ATTACHMENT A

SEP TOPIC III-5.A

HIGH ENERGY PIPE BREAKS INSIDE CONTAINMENT

DRESDEN NUCLEAR POWER STATION UNIT 2

FIGURE 7-1. MATHEMATICAL MODEL OF THE CONTAINMENT LINER - EVALUATION OF JET IMPINGEMENT EFFECTS

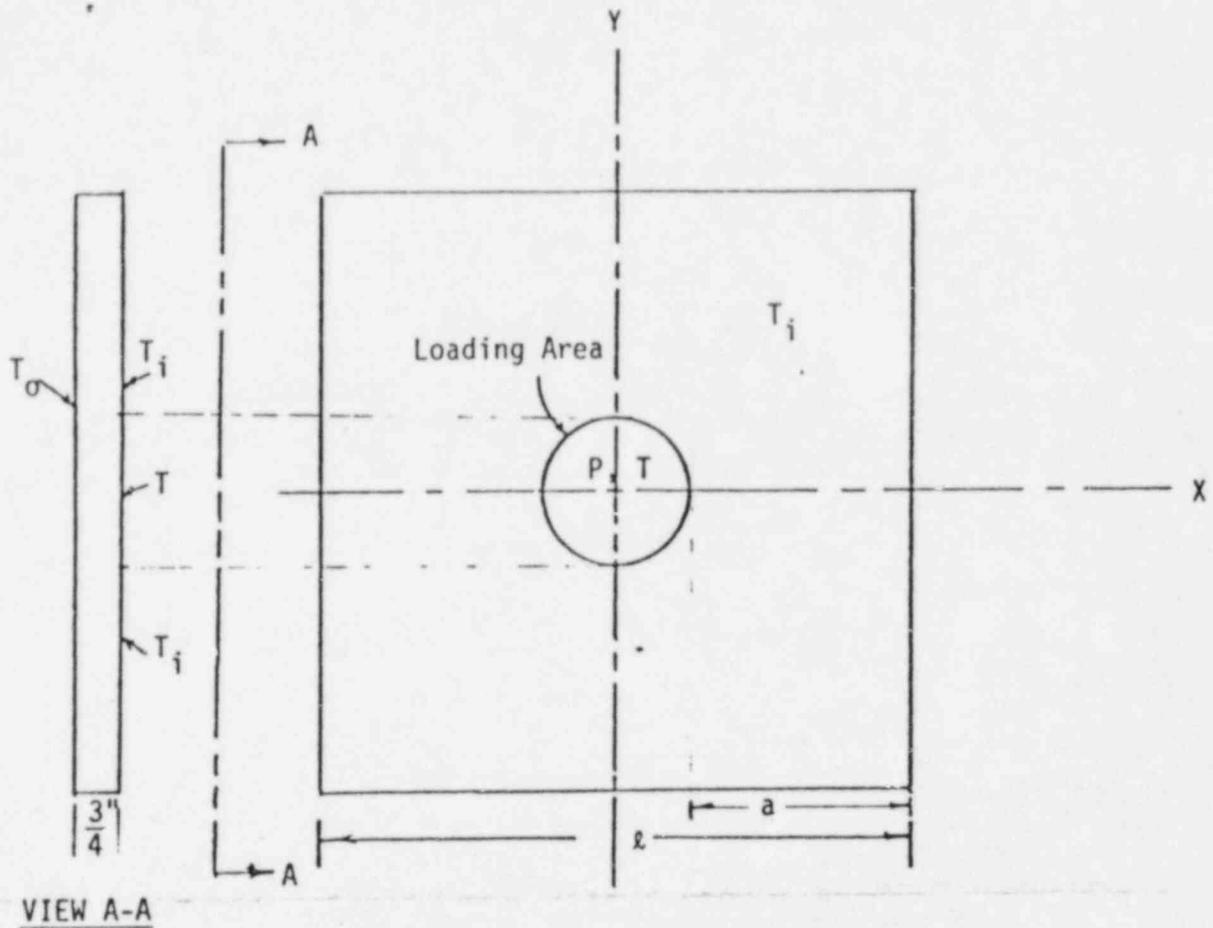
- c. The licensee should clarify the technical bases for Figure 4.2 of Reference 1 and the use of 2500 psi as an upper bound for jet impingement loading on the drywell liner (page 11, Reference 1).

The use of 2500 psi as an upper bound in the nonlinear finite element analysis is based on engineering judgment in order to limit excessive computational expense. An examination of Figure 4-2 (Reference 1), even for a circular loading area equivalent to 20 inches in diameter the curve is already tending toward being asymptotic at 2800 psi. The analysis was performed for circular loading areas as small as 4 inches in diameter in order to cover a full spectrum of target areas. The 2500 psi calculational limit does not imply that actual jet impingement pressures are limited to this value.

The mathematical model (shown in Fig. 7-1) represents a segment of the spherical portion of the containment liner. The center of the loading area is located at the center of the plate. The edges are assumed to be fixed. The dimensions of the model are chosen such that the boundaries are sufficiently far away from the edge of the loading area. Based on small deflection theory, Reference 5 gives the following formula for calculating the minimum distance of the boundary from the edge of the load, for neglecting the boundary conditions.

Since the structure, the loading, and the boundary conditions are symmetrical about both x-axis and y-axis (Figure 7-1), symmetrical distribution of the stresses and deflections is expected about x and y-axes. Hence, for the ANSYS finite element analysis, only one-quarter portion of the model located in the first quadrant is considered. The following boundary conditions are assumed in the ANSYS model:

A uniform pressure loading is applied in the jet impingement area. The magnitude of the pressure is gradually increased in steps until either the pressure reached 2500 psi (calculational limit), or the deflection of the liner is about 3".

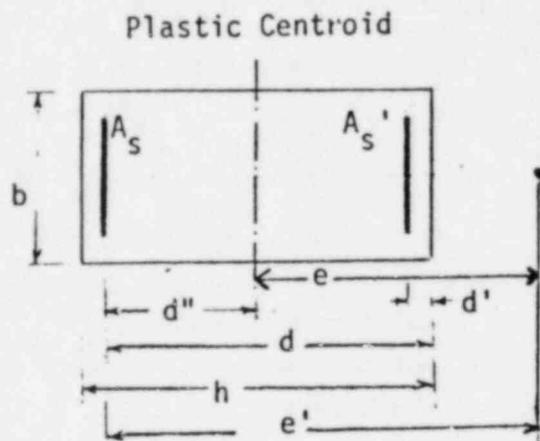
- d. The licensee should provide the detailed methodology including basic assumptions used in arriving at screening criteria for RPV pedestal and biological shield wall, i.e., the allowable pipe whip loads and maximum allowable jet impingement pressure, for postulated pipe break interactions with RPV pedestal and biological shield wall (Figures 4-3 and 4-4, Reference 1).

Bending stresses were based on the requirements of Chapter 10 of the ACI Code (Ref. 6). The pedestal wall was analyzed in both the hoop and meridional directions. Balanced section conditions were determined using the following equation (Ref. 7).

and the rest of the terms are shown in the sketch.

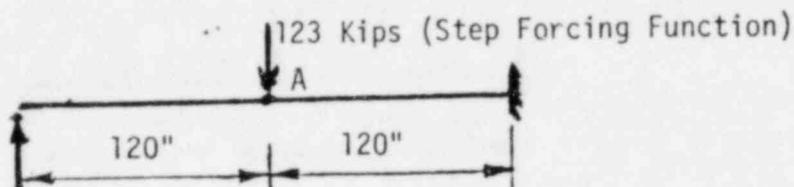
- B.9 In determining the acceptability of target pipe (Section 4.3.2 of Reference 1), the licensee has used a criterion that the limiting factor for an applied equivalent static load is that the resulting strain in the target pipe material does not exceed 45 percent of the minimum ultimate uniform strain of the material at the appropriate temperature. This criteria is acceptable for avoiding cascading pipe breaks. However, some piping systems are required to deliver certain rated flow and should be designed to retain dimensional stability when stressed to the allowable limits associated with the emergency and faulted conditions, i.e., the functional capability of the piping is required to be demonstrated. The licensee should provide justification to assure that the target piping will remain functional as a result of jet impingement and pipe whip interactions.

Plastic hinge formation of the target pipe is of a very localized nature and the zone of plasticity is limited essentially to the hinge location. It is therefore possible to achieve strain levels approaching 45 percent of the minimum uniform ultimate strain of the material in a localized region without affecting the overall deformation or functionality of the target pipe.

A parametric study covering a range of geometric and load parameters was performed using the ANSYS finite element program. The nonlinear dynamic analysis results indicated the coexistence of large localized strain levels and small global deformations. The above conclusion is illustrated by the following numerical results from the ANSYS computer program.

The plastic hinge which formed at point A (point of load application) reached a strain level of 45 percent of the minimum uniform ultimate strain of the material. The downward displacement of point A was 1.643 inches with an angle of rotation at the support of 0.78 degrees.
